Attachment II

Marked up copy of R.E. Ginna Nuclear Power Plant  
Technical Specifications

R.E. Ginna Nuclear Power Plant  
Spent Fuel Pool Re-racking Licensing Report  
February 1997

Figure 3.7.13-2  
Fuel Assembly Burnup Limits in Region 2

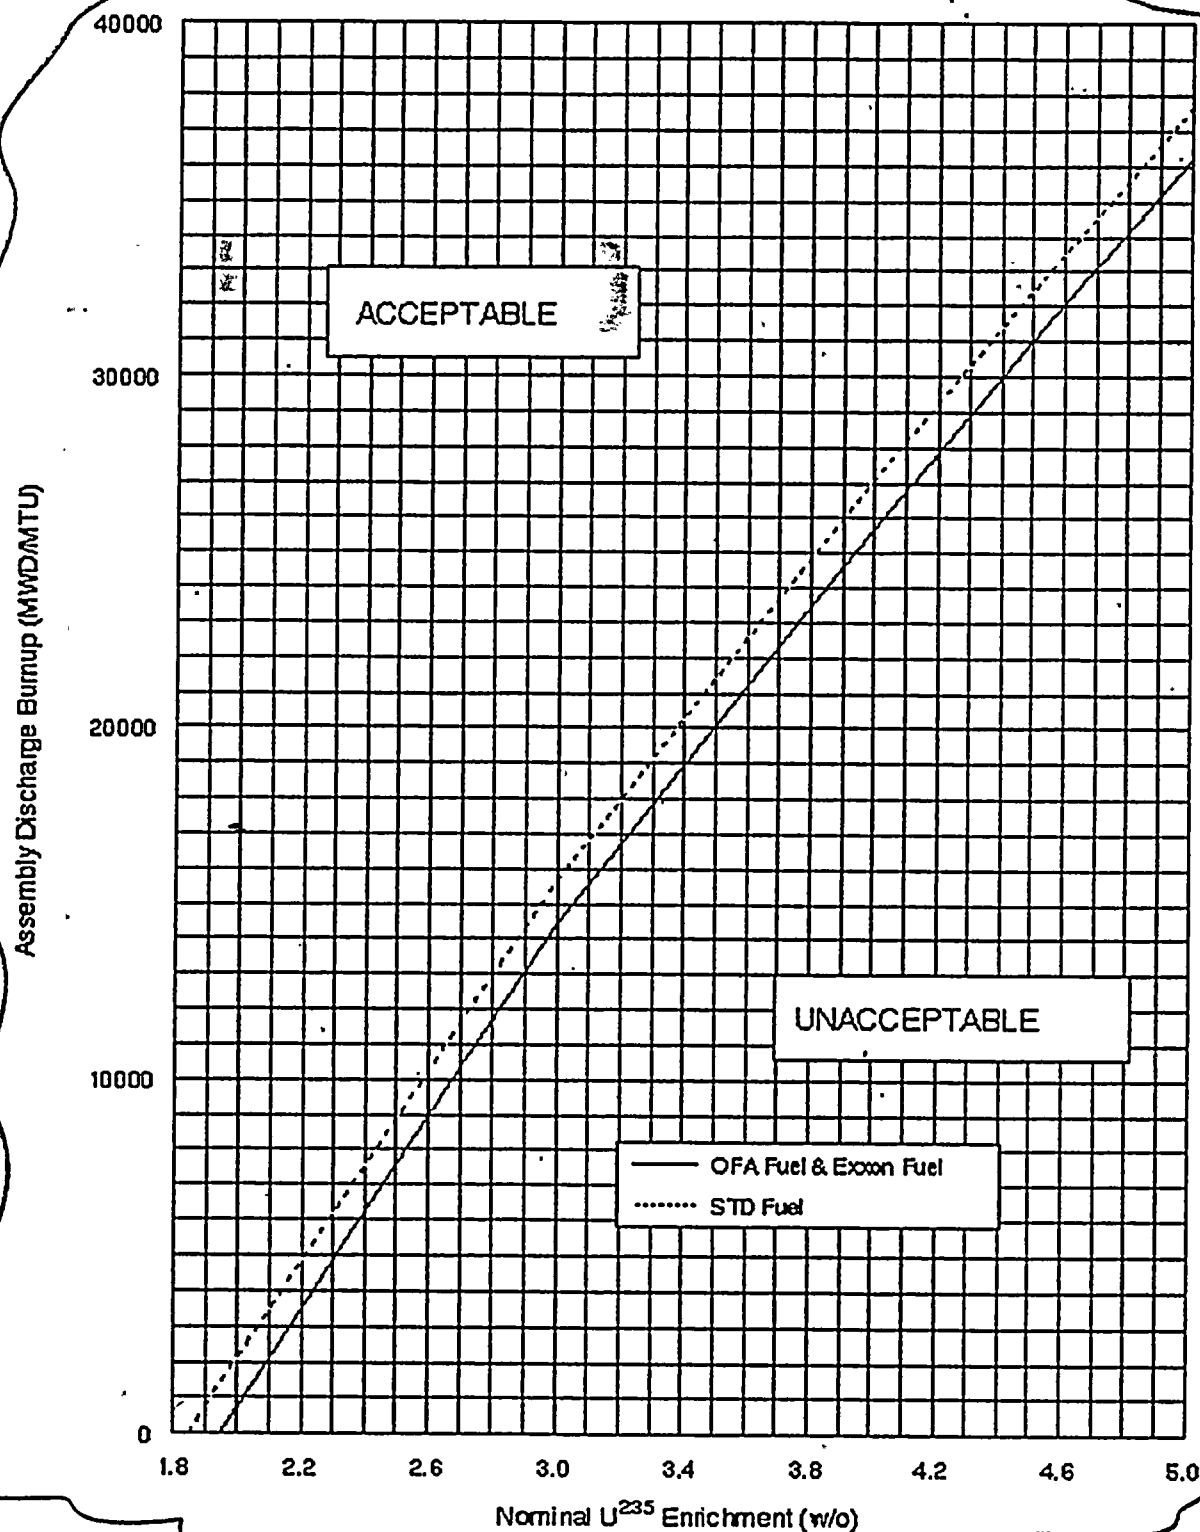
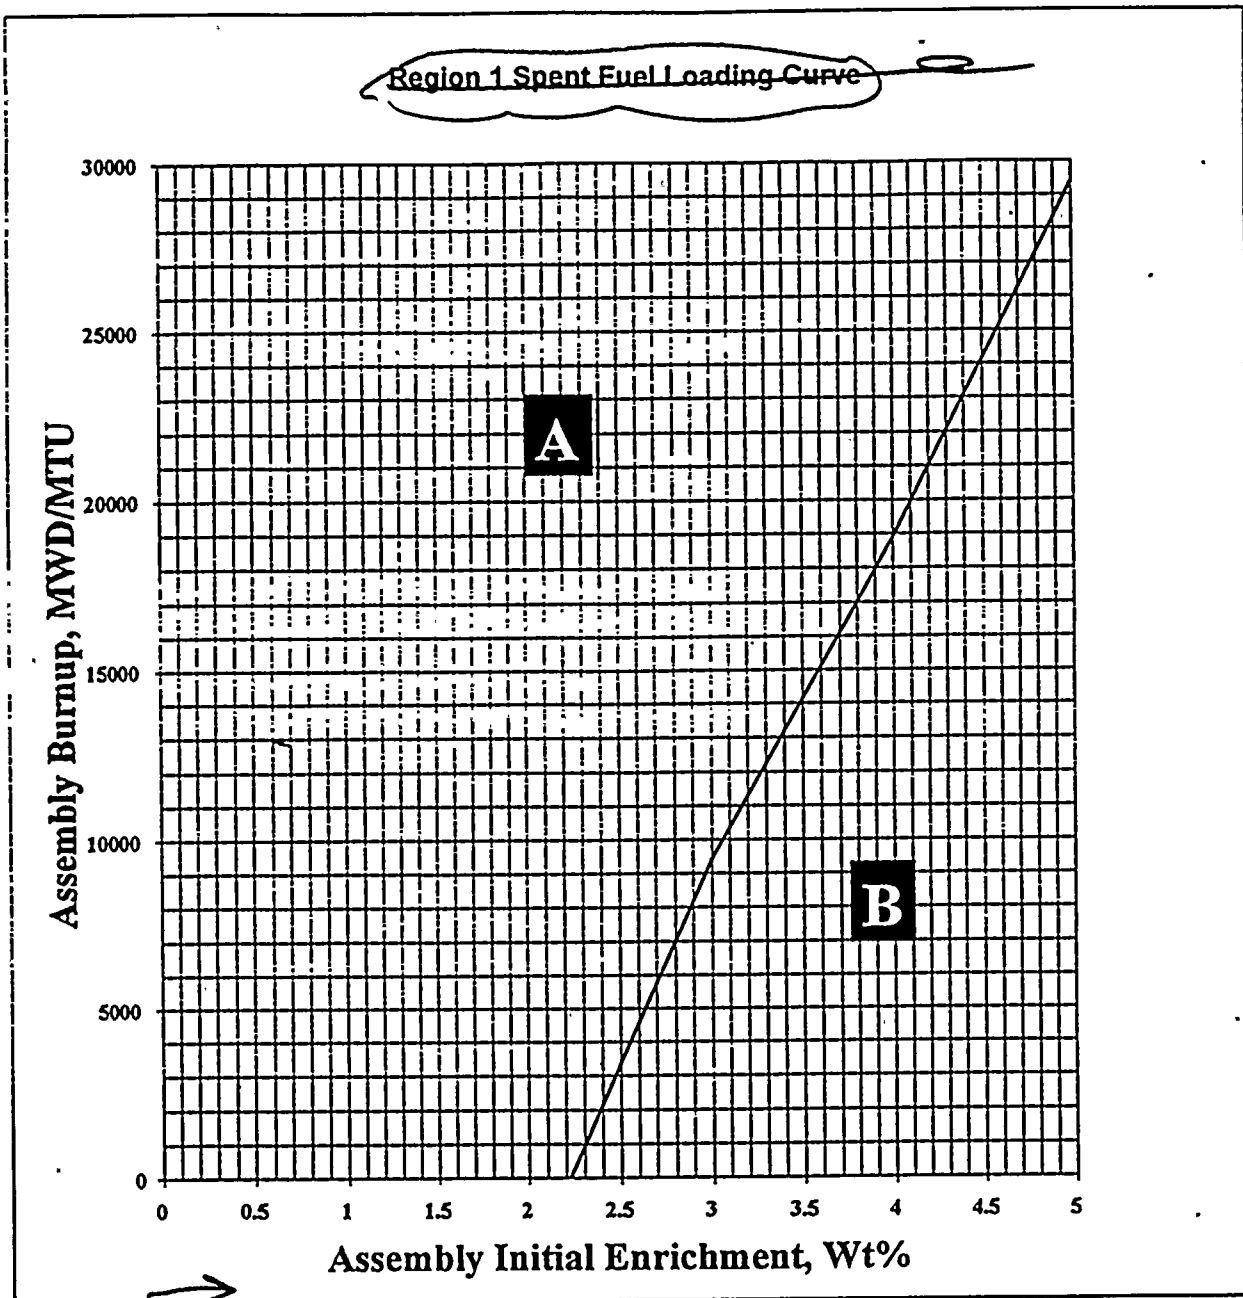
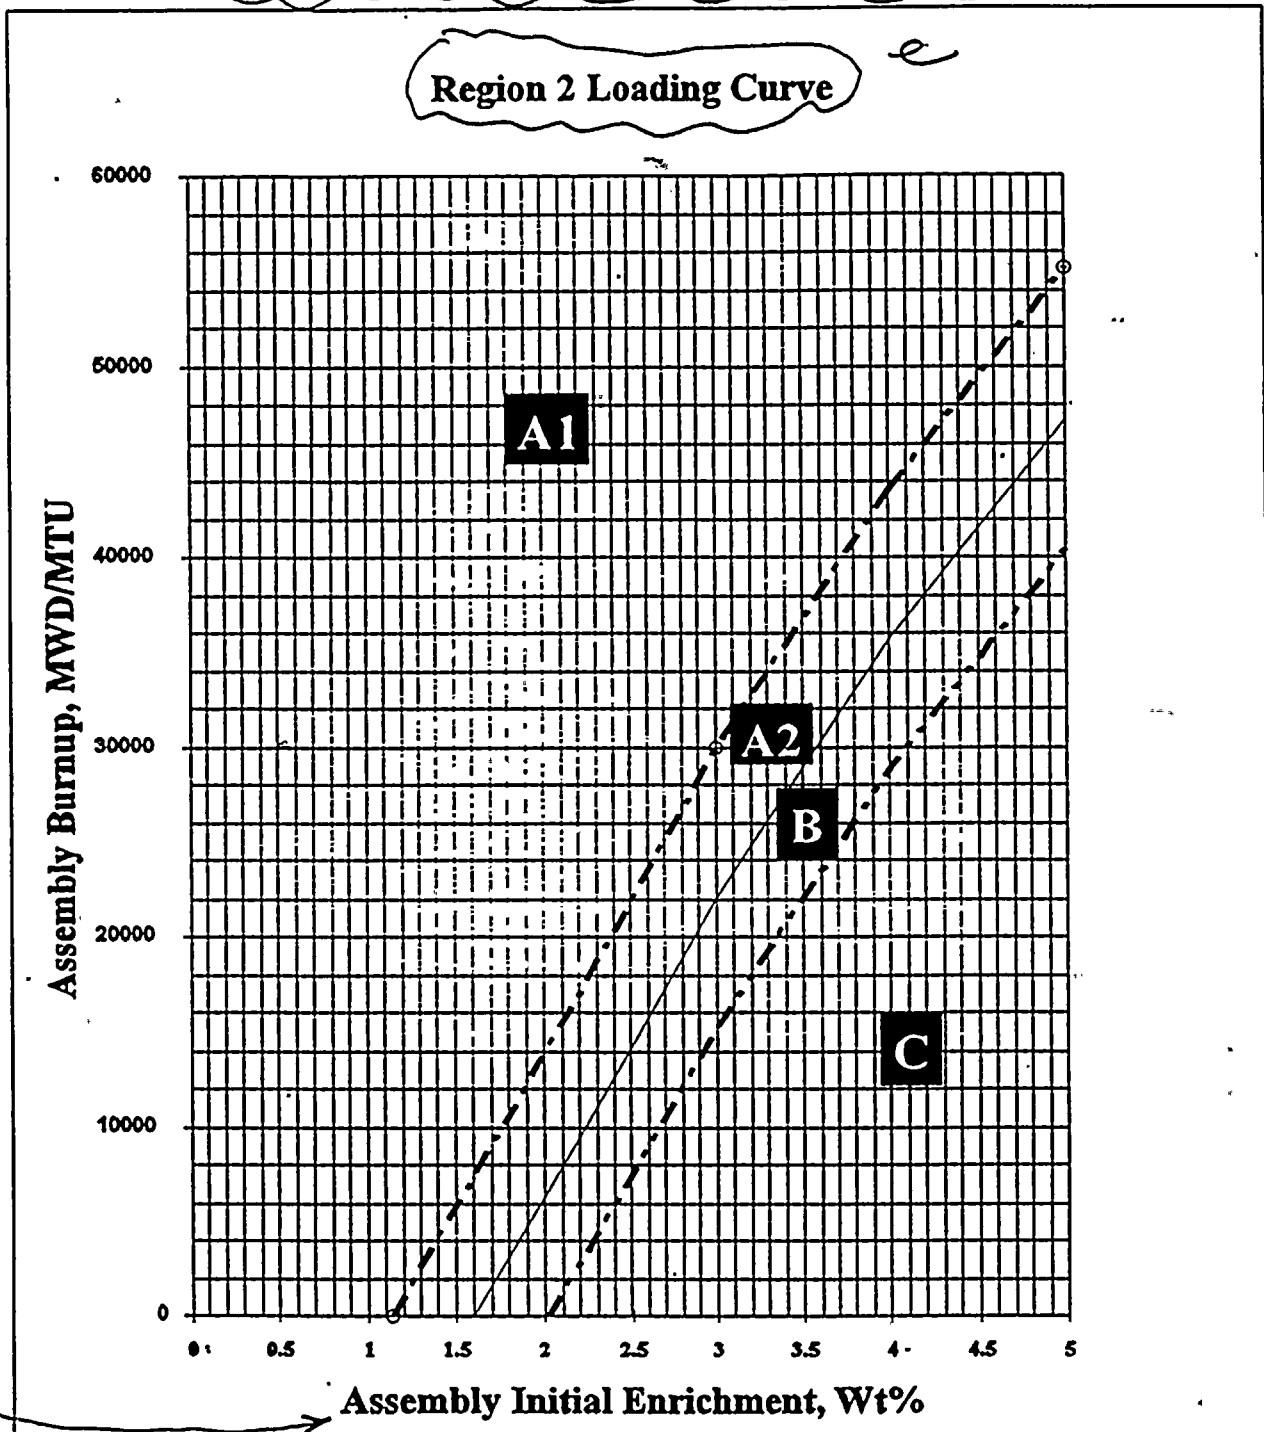
and shall have initial enrichment and burnup within the acceptable area of Figure 3.7.13-1

- a. Fuel assemblies in Region 1 shall have a K-infinity of  $\leq 1.458$ ; and
- b. Fuel assemblies in Region 2 shall have initial enrichment and burnup within the acceptable area of the Figure 3.7.13-1.

SURVEILLANCE		FREQUENCY
SR 3.7.13.1	<p>-----NOTE-----</p> <p>Not required to be performed when transferring a fuel assembly from Region 2 to Region 1.</p> <p>Verify by administrative means the K-infinity of the fuel assembly is <math>\leq 1.458</math>.</p> <p>and that the initial enrichment and burnup is in accordance with Figure 3.7.13-1.</p>	Prior to storing the fuel assembly in Region 1
SR 3.7.13.2	<p>Verify by administrative means the initial enrichment and burnup of the fuel assembly is in accordance with Figure 3.7.13-1.</p> <p>2</p>	Prior to storing the fuel assembly in Region 2

Insert new Figure  
3.7.13-1 and 3.7.13-2

- a. Fuel assemblies in Region 1 shall have a K-infinity of  $\leq 1.458$  and shall have initial enrichment and burnup within the acceptable area of Figure 3.7.13-1; and
- b. Fuel assemblies in Region 2 shall have initial enrichment and burnup within the acceptable area of the Figure 3.7.13-2.

SURVEILLANCE		FREQUENCY
SR 3.7.13.1	Verify by administrative means the K-infinity of the fuel assembly is $\leq 1.458$ and that the initial enrichment and burnup is in accordance with Figure 3.7.13-1.	Prior to storing the fuel assembly in Region 1
SR 3.7.13.2	Verify by administrative means the initial enrichment and burnup of the fuel assembly is in accordance with Figure 3.7.13-2.	Prior to storing the fuel assembly in Region 2

Figure B 3.7.13-1  
Spent Fuel Pool

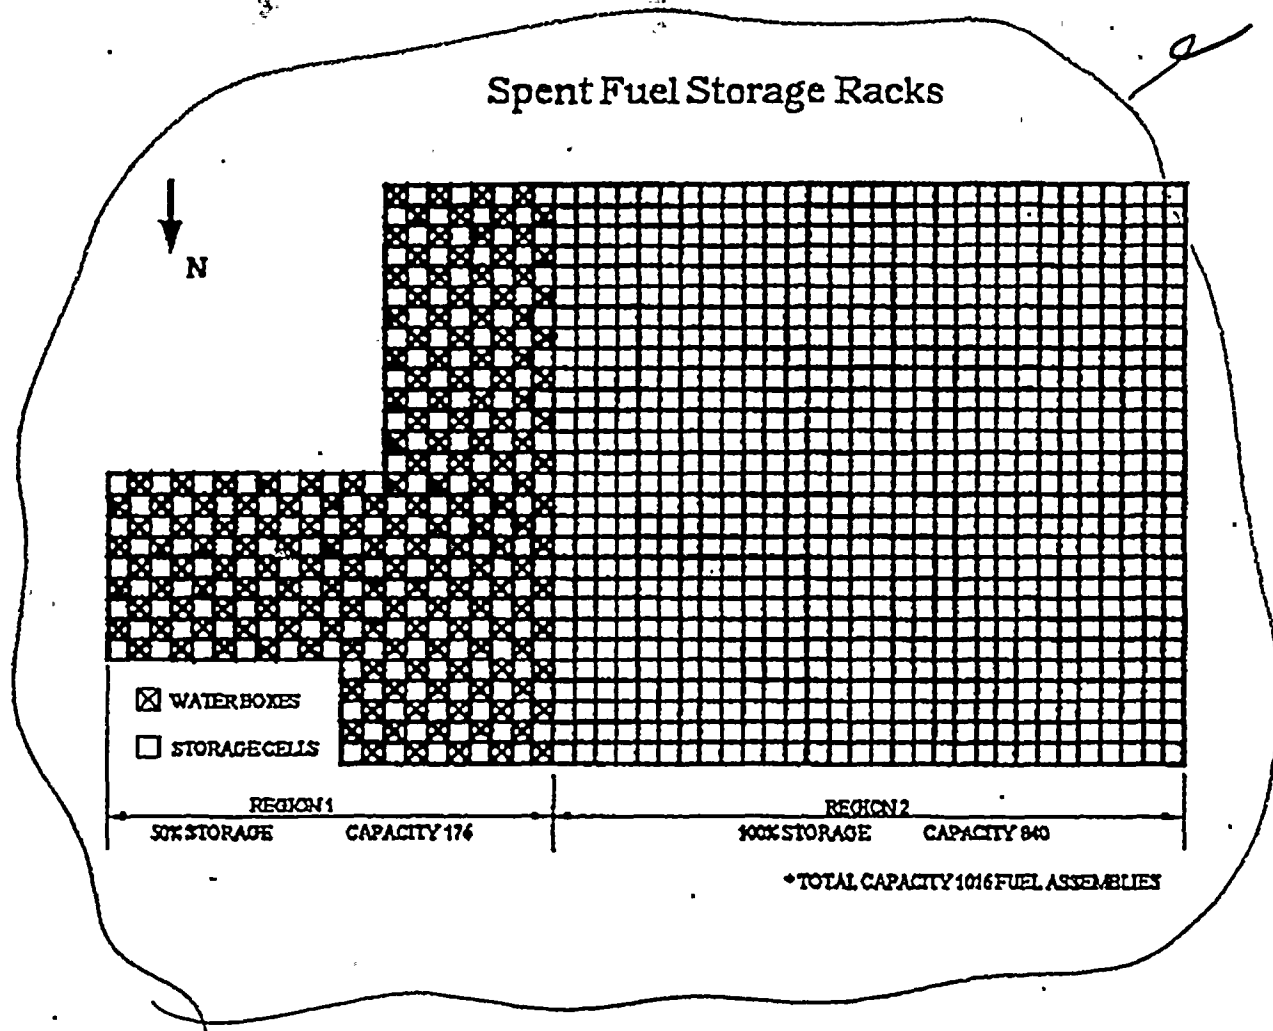
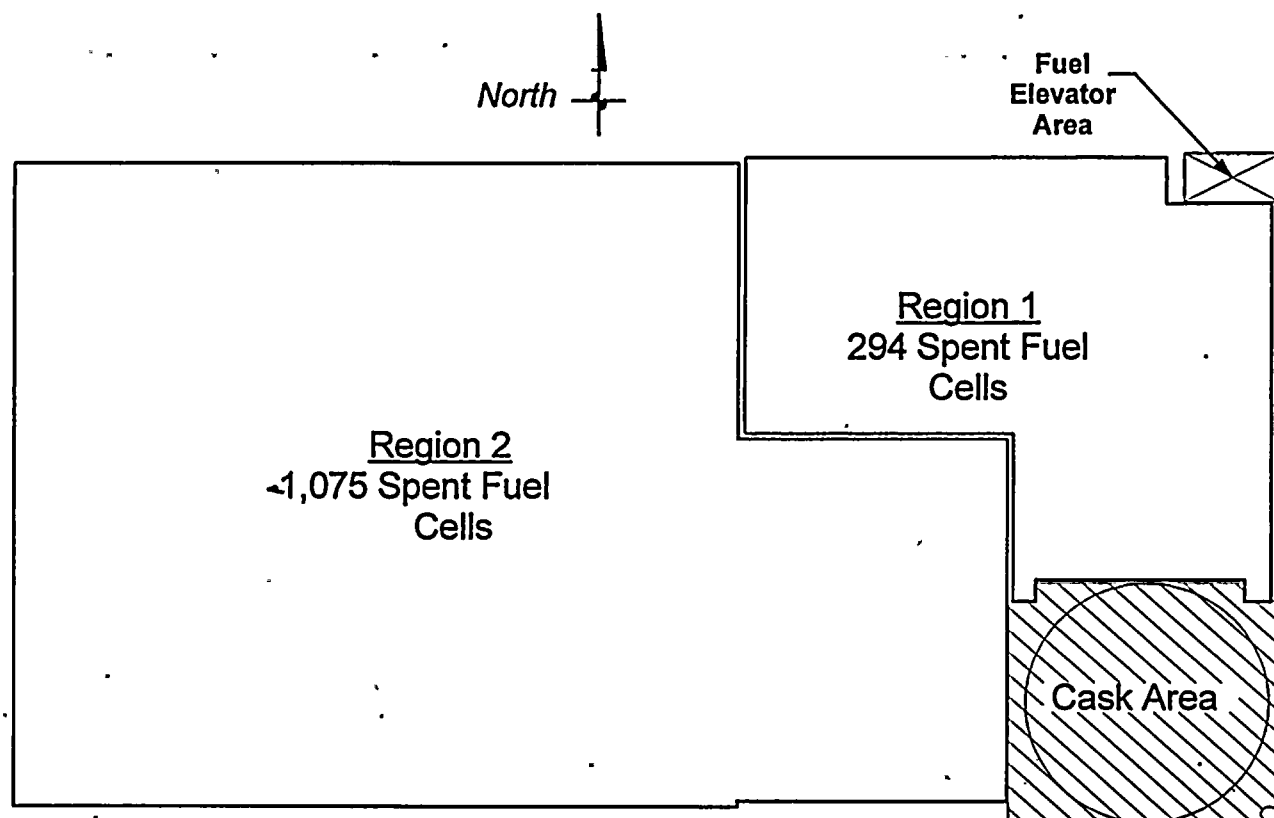
replace
